AF83.00-P-1002AG	Clicking noise and malfunction of center air outlet	7.7.06
------------------	---	--------

MODEL 163.### #A as of 289560,
163.### #X as of 754620

P83.30-3661-01

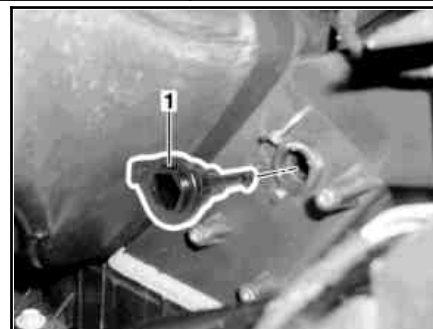
Damage code	Cause	Remedy	
68 239 06	Stop on sleeve for center air outlet broken off. i The missing stop on the sleeve of the center air outlet can lead to clicking noises.	i Warranty return deliveries have shown that the air outlet module has been replaced. Replacement of the center air outlet is not necessary and results in high costs. The sleeve for the center air outlet can be replaced. 1 Remove actuator motor of center air outlet.	AR83.10-P-2019GH
		2 Remove sleeve (1) for center air outlet from the AC housing. i Dispose of defective sleeve.	
		3 Install sleeve (1) in the AC housing i Use new sleeve as per the Parts ordering notes	
		4 Reinstall actuator motor of center air outlet.	AR83.10-P-2019GH

Part no.	Designation	Quantity
163 683 09 54	Sleeve for center air outlet	1
